**Committee of Experts on the Transport of Dangerous Goods  
and on the Globally Harmonized System of Classification  
and Labelling of Chemicals**

**Electric storage systems: testing of lithium batteries**

**Activation of Lithium Cell or Battery Protective Mechanisms  
and Criteria for Voltage Loss Limit in T.2 Thermal Test in  
UN Manual of Tests and Criteria - Section 38.3**

**Transmitted by PRBA – The Rechargeable Battery Association and  
RECHARGE**

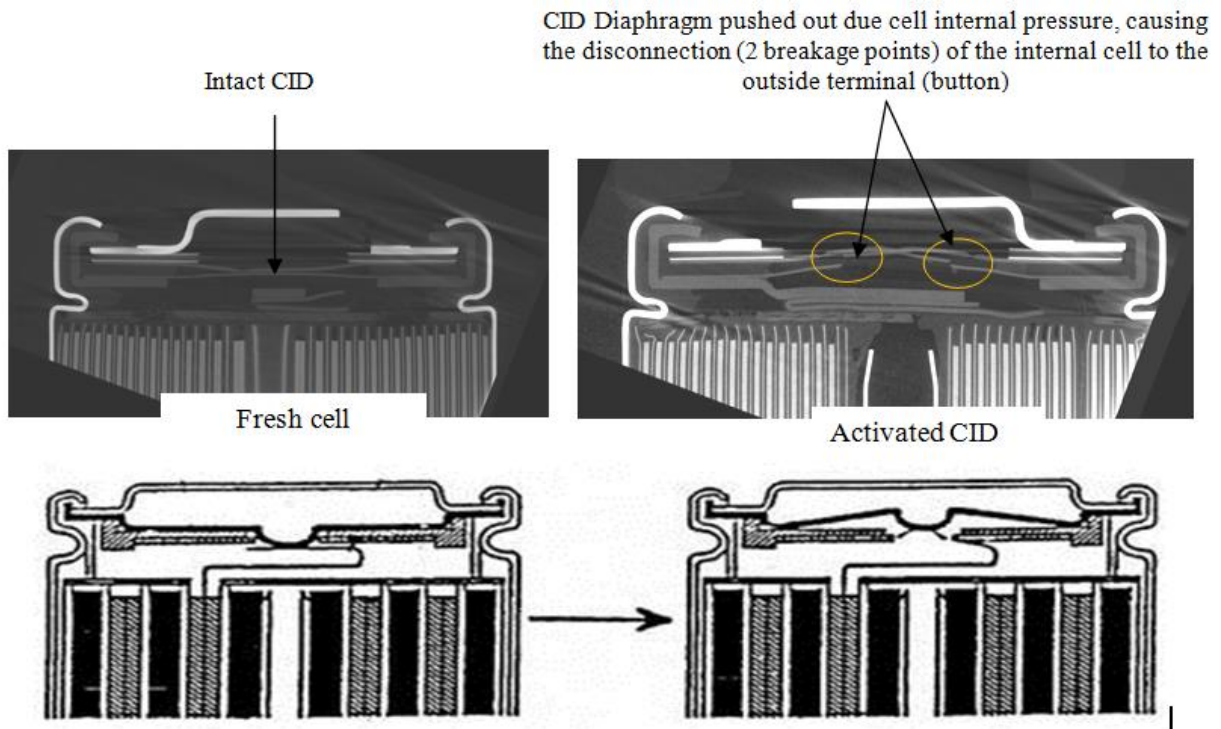
5. The X-ray images and graphics below show a comparison between a normal and activated cell CID mechanism. In the activated CID image, under internal cell pressure, the diaphragm connections to the button are broken, resulting in disconnection of the internal cell to the outside terminal (cell button). This disconnection results in low open circuit voltage (close to 0V) measured between the cell terminals. (The same logic as above applies to activation of the battery safety protective device mechanisms.)
